Technical Service Bulletin

MODEL(S) AFFECTED: **T3/T3+ Models with Propel**

SUBJECT: False Battery Discharge Indicator reading. If BDI charge level rapidly drops upon machine start up, the control board module may have a program error.
Note: The actual run time is not affected by false BDI reading, the batteries will continue to discharge as normal.

Replacement Control Board Module Rev. 03 (p/n 1052260).

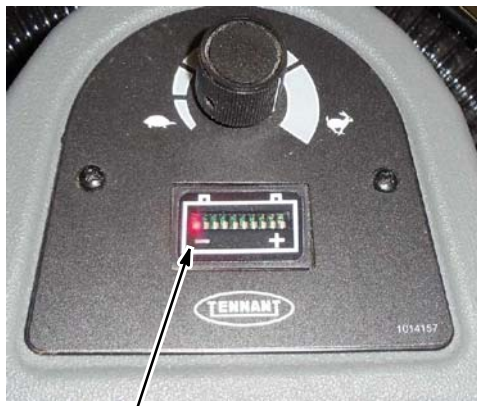
PURPOSE: To correct the BDI reading, replace the control board module with revision 03 (p/n 1052260). The revision level is located on module's label as shown below.

False BDI reading when batteries are fully charged. The actual run time is not affected by the false reading, the batteries will continue to discharge as normal.

Replace control board module with Revision 03.

Note: The new module revision level 03 may be hand-written due to existing inventory was reprogrammed.
